Duquesne Light

SUBJECT: Beaver Valley Power Station - Unit No. 2
Docket No. 50-412
Responses to ER Site Visit Action Items

Please find enclosed responses to Action Item Nos. 1, 2, 3, 4, 6, and 7 that were requested in the Environmental Site Visit Meeting Summary letter to Duquesne Light Company dated May 8, 1984. All responses to Action Items referenced in the above letter have now been submitted for staff review.

Figure 2

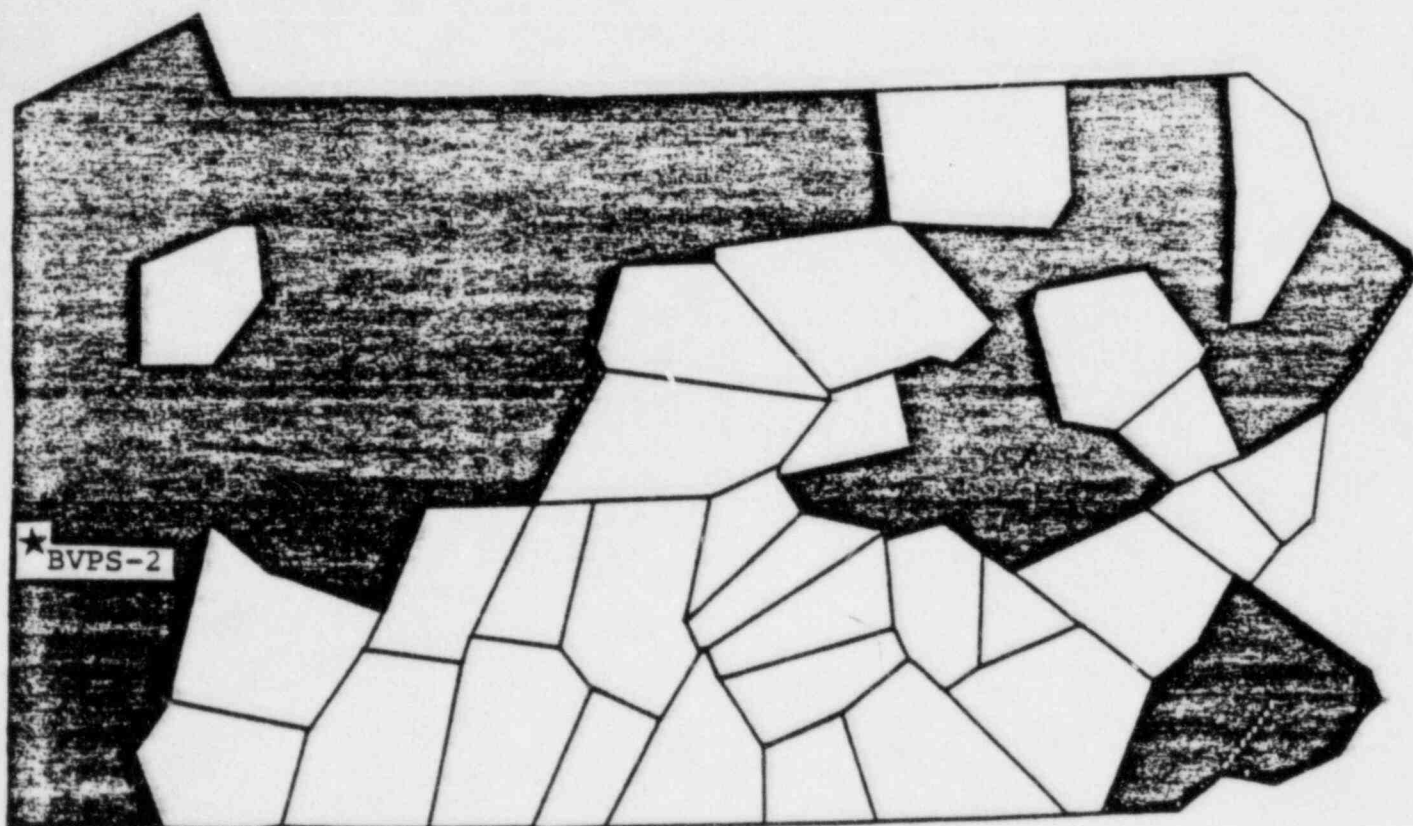
6. Provide a copy of the State endangered/threatened species list and relevant information on known/expected distributions of listed species.

The Pennsylvania Game Commission maintains a wildlife data base to provide information on distribution and habitat preference for numerous fish and wildlife species. This includes information on the presence or absence of each species by county. Ten of the 13 state-listed endangered or threatened species are expected to be present in all counties of Pennsylvania. The other three species are expected to be present in some counties, and their occurrence in the remaining counties is unknown. Figures 1 through 4 display the distribution of all state-listed endangered or threatened species in the Commonwealth of Pennsylvania. None of the state-listed threatened/endangered species has been confirmed to be absent in any county.
